Parks, Municipal Services Department

Blackrock Park Masterplan 2020

Have Your Say Public Consultation Report

Date: 30th Sep 2020

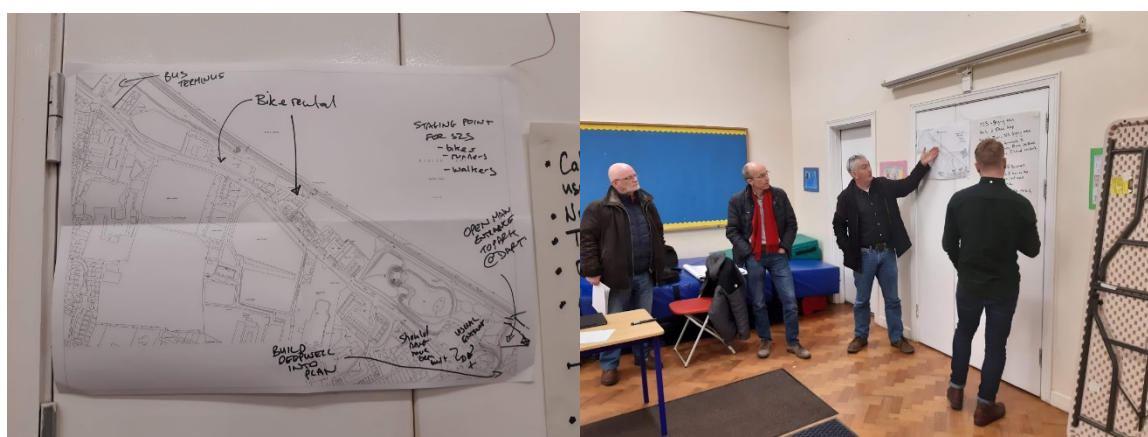
To conclude, the suggested improvements offered through the submissions centre on providing the basic amenities and facilities to make the park more useable. The submissions also highlight the dilapidated and underutilised state of many of the original park features. There is also a clear demand to improve the use of the park in both a passive and active way. Passive elements include improved nature value and a more comfortable/safer user experience. Active elements include exercise equipment and appropriate structured sport facilities.

The masterplan layout addresses all the praise, concerns and suggestions made through the consultation process. The overall goal of the masterplan is to transform the park into a desirable
